Access Compliance Report

Public Rights-of-Way

(Curb Ramps)

Intersection ID: 14852	Main Street: HARRISBURG_RD	Cross Street: SHACKLEFORD_TR	Location: NW
ADA ID: 21F09F044CBB	Ramp Type: PerpDiag	Initial Pass/Fail: Fail	Overall Compliance: No
		Severity Score: 10

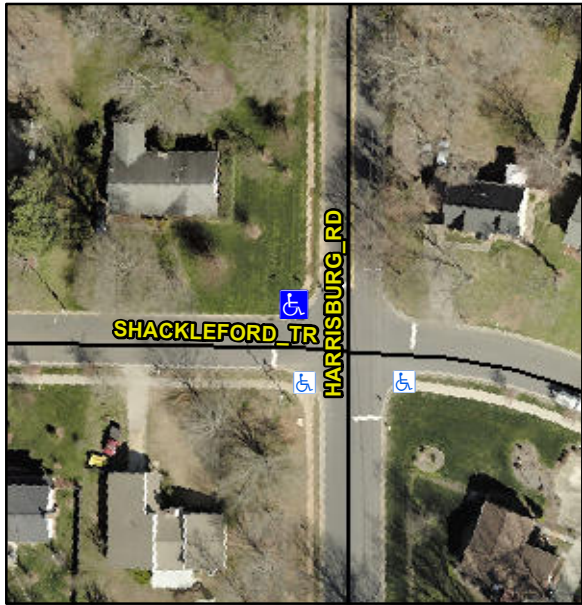
Codes/Mitigation Info/Possible Solution			Field Measurements/Component Compliance					
	Possible Solutions:		Compliance	Description	Data	Compliance	Description	Data
	Remove & Replace Curb Ramp With Two New Directional Ramps or Equivalent.		N/A	Ramp Length (in)	85.0	Yes	Ramp Slope (%)	6.9
			No	Ramp Width (in)	44.5	No	Ramp XSlope (%)	2.4
			N/A	Flare Type LT	N/A	N/A	Flare Type RT	N/A
			N/A	Flare Slope LT (%)	N/A	N/A	Flare Slope RT (%)	N/A
			N/A	Flare Traversable LT?	N/A	N/A	Flare Traversable RT?	N/A
			N/A	Landing Length (in)	N/A	N/A	DWS Provided?	N/A
			N/A	Landing Width (in)	N/A	N/A	DWS Contrast?	N/A
			N/A	Landing Slope (%)	N/A	N/A	DWS Length (in)	N/A
			N/A	Landing X Slope (%)	N/A	N/A	DWS Full Width?	N/A
Surveyor Notes:		N/A	N/A	Landing Curb? (Y/N)	N/A	N/A	DWS Offset (in)	N/A
PROW/ADA:		R304.5.1, R304.5.3	N/A	Shared Landing?	N/A			
			N/A	Gutter Ponding?	N/A	N/A	Gutter Slope (%)	N/A
			N/A	Gutter Lip Ht (in)	N/A	N/A	Gutter X Slope (%)	N/A

N/A	Painted X Walk1?	No	N/A	Painted X Walk2?	No
				X Walk 1 Direction	To SW		X Walk 2 Direction	To SE
			N/A	X Walk 1 Width (in)	N/A	N/A	X Walk 2 Width (in)	N/A
				X Walk 1 Slope (%)	5.8		X Walk 2 Slope (%)	2.6
				X Walk 1 X Slope (%)	0.4		X Walk 2 X Slope (%)	4.5
			N/A	Ramp inside XWalk1?	N/A	N/A	Ramp inside XWalk2?	N/A
				Road Slope (%)	2.0	N/A	Clear Space?	N/A
				Road X Slope (%)	7.6	N/A	Clear Space to XWalk (in)	N/A
			N/A	Any Obstructions?	N/A	N/A	Storm Grate/Utility Hazard?	N/A
				Obstruction Type			Storm Grate/Utility Type	
					N/A			N/A
						Yes	Surface Condition? (G/P)	Good
Street 1 Name			SHACKLEFORD TR					
Stop Condition-Street 2			StopSign					
Street 2 Name			HARRISBURG RD					
Stop Condition-Street 1			StopSign					
Total Cost:			\$	3200.00
